Från: "Bruno Putzeys" <bruno@hypex.nl>
Till: "Patrik Boström" <Patrik.Bostrom@Anaview.com>
Kopia: <info@hypex.nl>
Skickat: den 26 januari 2009 08:50
Ämne: Re: Too little gain

From: Patrik Boström
To: Bruno Putzeys
Sent: Tuesday, January 13, 2009 1:51 PM
Subject: Too little gain

From: Patrik Boström
To: Bruno Putzeys
Cc: Jan-Peter van Amerongen
Sent: Friday, April 03, 2009 11:00 AM
Subject: UcDi designs for Alpine

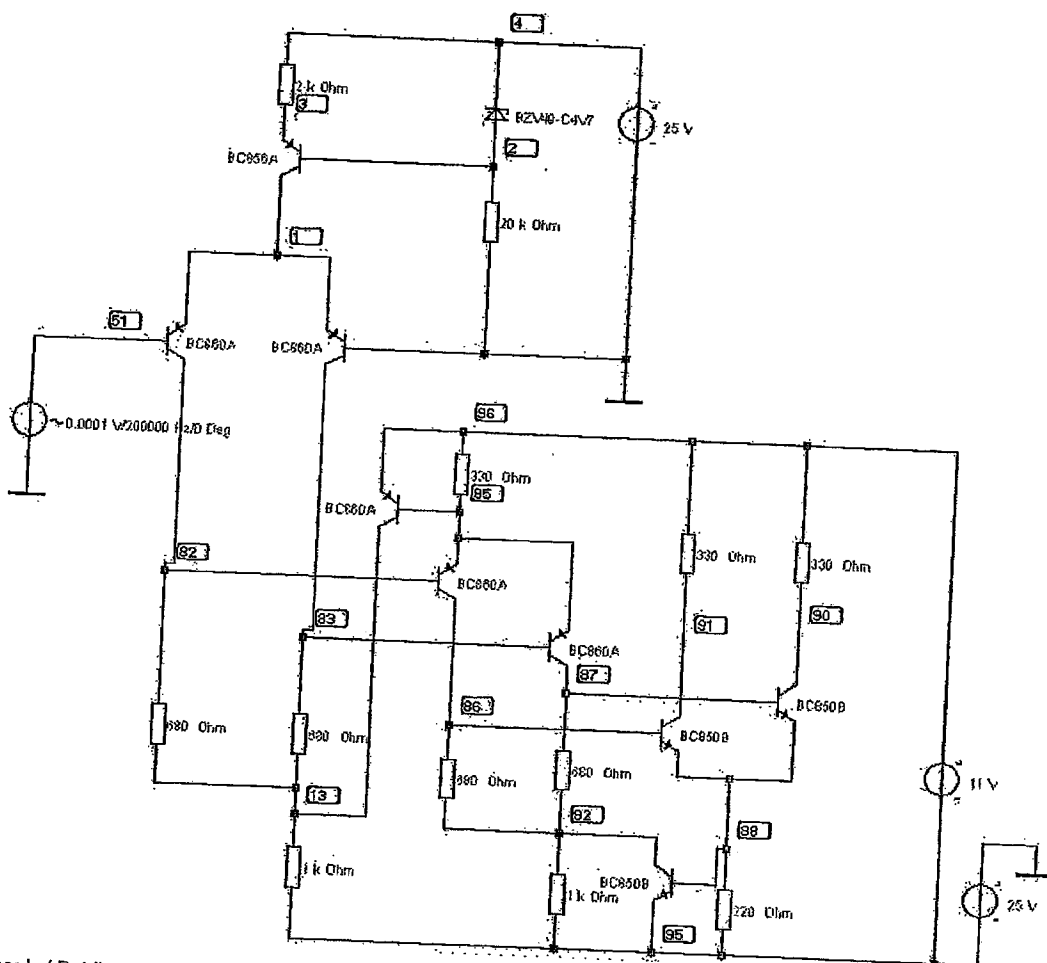
Here it is!

Using your improved second stage from the UcDi comparator helps a lot and it gives even higher gain but it adds five parts. A simpler version would find it place in the world.
